## **REMARKS**

Patent S.N. 09/642,911 6822/62934

## **AMENDMENTS TO THE DRAWINGS:**

FIG. 16

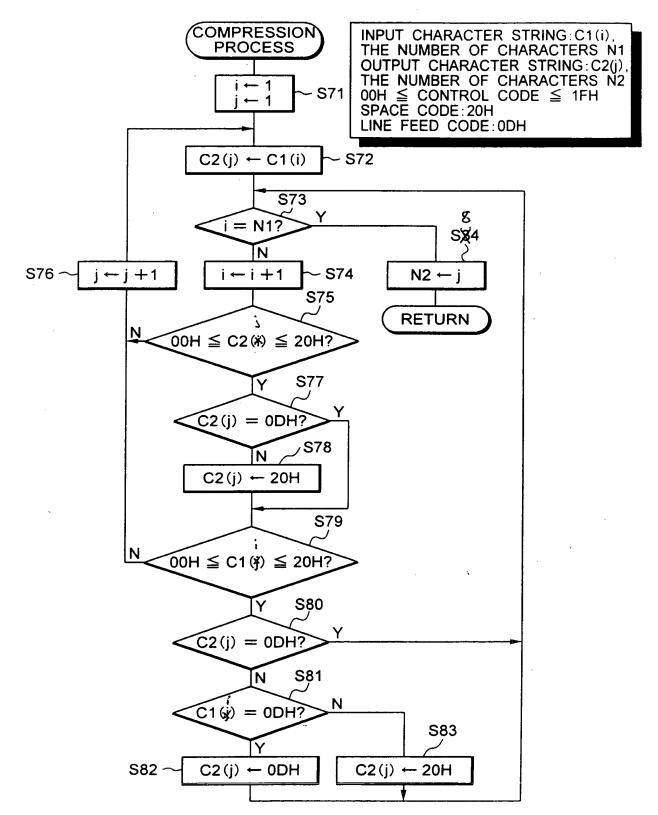
The attached sheet of drawings includes the following changes to Fig. 16:

```
"C2(i)" is changed in S75 to "C2(j)";
```

"C1(j)" is changed in S79 to "C1(i)";

"C1(j)" is changed in S81 to "C1(i)";

"S34" is changed to "S84".
